MINUTES OF THE CITY OF SANTA FE ARCHAEOLOGICAL REVIEW COMMITTEE HEARING City Councilors Conference Room July 16, 2015

1) CASE #AR-19-15. SUBURBAN ARCHAEOLOGICAL REVIEW DISTRICT.
ARCHAEOLOGICAL DATA RECOVERY PLAN FOR LA 79935 IN THE MONTE
SERENO RESIDENTIAL DEVELOPMENT AT 325 PAWPRINT TRAIL. RON
WINTERS FOR CHARLES AND SUSAN LUCERO. (LISA ROACH)

2) <u>CASE #AR-22-15.</u> RIVER AND TRAILS AND SUBURBAN ARCHAEOLOGICAL REVIEW DISTRICTS, ARCHAEOLOGICAL MONITORING PLAN FOR THE PROPOSED CITY OF SANTA FE PARKS PLAYGROUND SHADE STRUCTURES PROJECT. RON WINTERS FOR THE CITY OF SANTA FE. (LISA ROACH)

RE: Changes to the Cyber Mesa Segment 1 work plan in the vicinity of the intersection of East Alameda and Don Gaspar Avenues. (AR-22-14)

Figure 5. Conduit route; Segment 1.

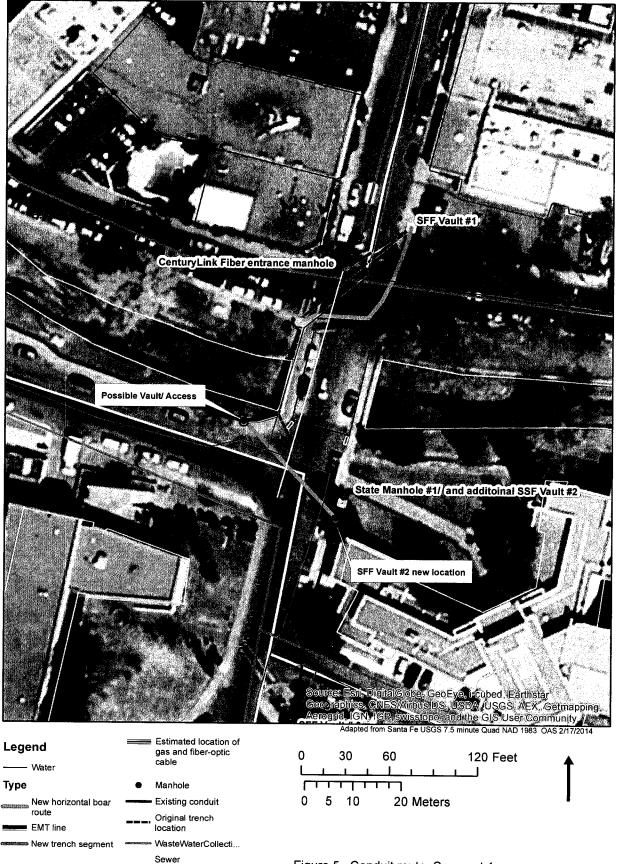
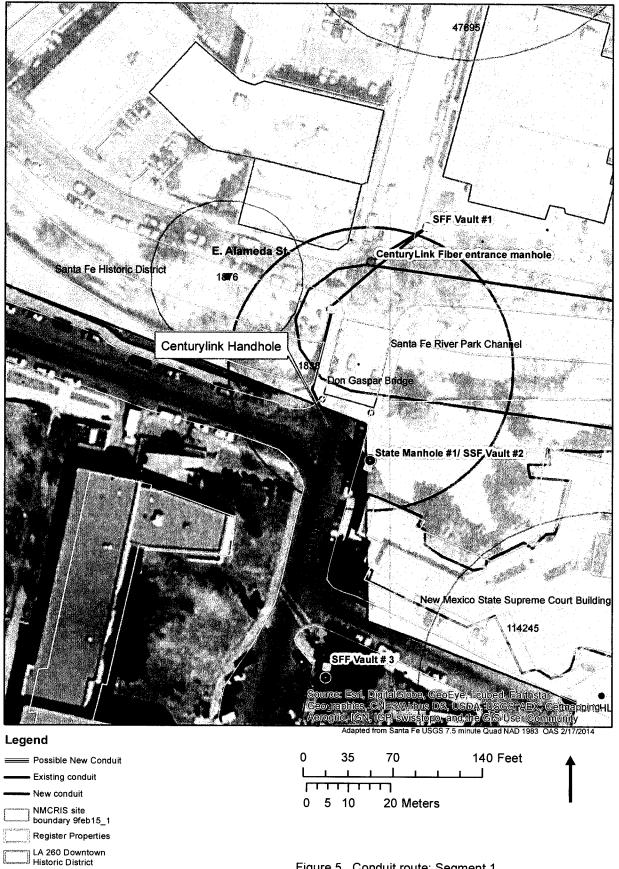
Ms. Roach said in Figure 5A, you can see the original trench location crossing Don Gaspar and then it goes along the bridge, crosses Alameda and back to a point at Don Gaspar and Alameda.

Mr. Ivey asked the reason the new orange routes don't join with any of the old routes.

Ms. Roach said there is a black and yellow line, that says "EMT line," and she presumes that would be a connection between the new bore route and the conduit that is going along the bridge.

Ms. Roach said instead of trenching across Don Gaspar and Alameda they are proposing to bore in those locations and to trench one small segment north of Alameda to Vault I.

Cyber Mesa Computer Systems Inc. has proposed minor changes to the excavation plan approved by Archaeological review Committee dated Feb 23, 2015 at the intersection of East Alameda/ West Alameda and Don Gaspar Avenue, and south of the Don Gaspar bridge at the intersection of Don Gaspar Avenue and West De Vargas St. These changes to the original plan are necessary because of the existence of a series of utilities that impede the construction plan as originally written for the intersection. Utilities at issue include but may not be limited to:

The original plan proposed installation of fiber-optic line by means of mechanical trenching (see Figure 5 of AR-22-14- attached) because this is not feasible in some areas this addendum proposes the alternatives listed below and shown in Figure 5a:

- 1) Horizontal boring from a point approximately 5 m south of State Manhole and New SSF Vault #2 to a new vault located in the sidewalk south and west of the storm drain.
- 2) Excavation of an origination pit no larger than 4 ft. long and 2 ft. deep by 18 in wide in the sidewalk at the north end of the bridge. Horizontal boring from this point northeast within the intersection to the west bound lane of Alameda where hand and mechanical excavated trench will continue north approximately 36 ft. to SSF Vault #1.

Mr. Pierce said, "They are not within the confines of the known site, but close, but outside the boundary. And what I like about it is they seem to take a minimum distance necessary for them to cross the street and it is not running parallel to the street, and it's not out in space. It's the straightest line possible, so I personally don't have issues with this."

It was the general consensus among the Committee in attendance that Ms. Badner should proceed as proposed in her letter, noting Gary Funkhouser was recused from participation on this agenda item.
